# Technical Bulletin

## PJ 62 Trimmer - New Feature Extended Housing for Increased Robustness

PJ 62 Existing

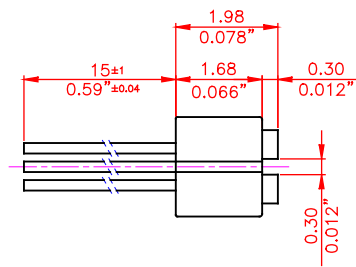
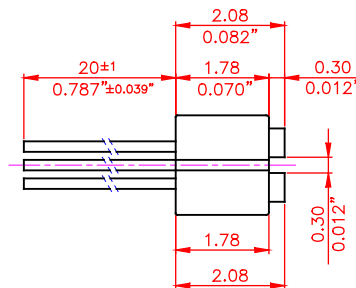
Sonion is pleased to announce that a new feature, which improves the robustness of the component, is now available for the PJ 62 Trimmers. The new feature - extended housing no. 12 and thicker resistance element - is illustrated above.

Compared to the previous version, the improved PJ 62 Trimmer has the following features:

- Improved mechanical and electrical reliability
- Significantly improved robustness

Please note that the PJ 62 version with extended housing no. 12 also has 20 mm leads instead of the previous 15 mm leads.
